Final Environmental Impact Report

San Bernardino County Overnight Solar Project

SCH No. 2024010434

2.0 COMMENT LETTERS AND RESPONSES TO COMMENTS

Figure 3.3-5. Burrowing Owl Survey Results

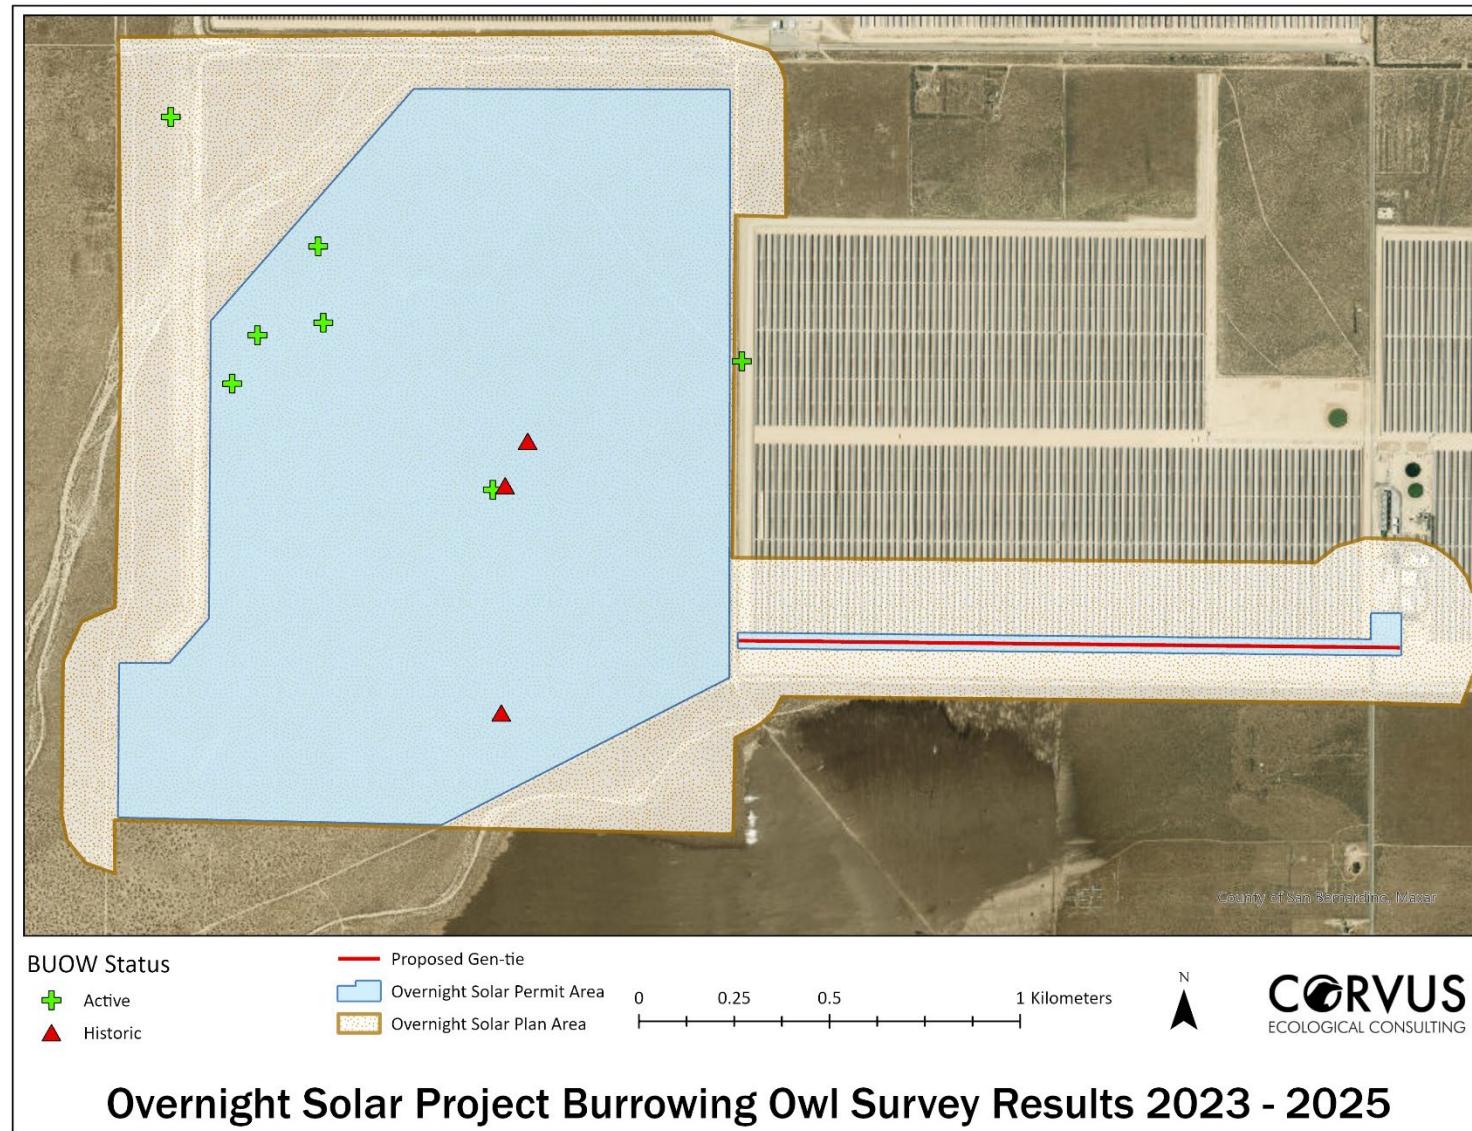
No living desert tortoises have been identified within the final proposed project footprint during any project surveys, but seven live desert tortoises were observed within the survey area (outside of the project footprint) as shown in Figure 3.3-3 of Section 3.3, Biological Resources, of the Draft EIR. The locations of these observations has been clarified in **Section 3.0, Minor Revisions to the Draft EIR**, of the Final EIR.

Initial burrowing owl surveys were conducted during peak breeding season in 2023 (April 15 to July 15), with two biologists walking 10-meter belt transects across the original survey area. Biologists examined natural and artificial substrates for occupation by western burrowing owl, and recorded ~~signs~~evidence of use (i.e., feathers, pellets, burrows, whitewash, egg fragments, live animals/breeding pairs, and live birds). Biologists marked all occupied and suitable burrowing owl burrows during this effort. During May 2023, ~~and April 2024, and March 2025~~, all suitable western burrowing owl burrows were revisited in an effort to determine occupancy and site use. Additional western burrowing owl focused surveys were performed in May, June, and July 2024, within the current project site and a 150-meter buffer. ~~The proposed gen-tie corridor was surveyed for burrowing owl on March 26, 2025. Signs of burrowing owl use were considered “historic” if detected within 2023 or 2024 and “active” if detected within 2025. No live~~~~Three historic signs and five active signs of burrowing owls use were have been observed within the current project footprint, one active sign of burrowing owl use has been observed northwest of the project footprint, and one active sign of burrowing owl use has been observed within the Mojave Solar Facility (Figure 3.3-5)~~; however, evidence of their presence was recorded in the form of active soil burrows, scat, and pellets (Figure 3.3-3). ~~The occupied burrowing owl burrow within the 150-meter buffer of the current project footprint within the existing Mojave Solar Facility, was detected more than 875 meters from the proposed project gen-tie located in the facility (Figure 3.3-5)~~. However, no signs of burrowing owl use were observed along the proposed gen-tie corridor within Mojave Solar Facility during the 2025 surveys. For these reasons, western burrowing owl is ~~assumed~~ determined to be present within ~~and around~~ the project ~~footprint~~site.
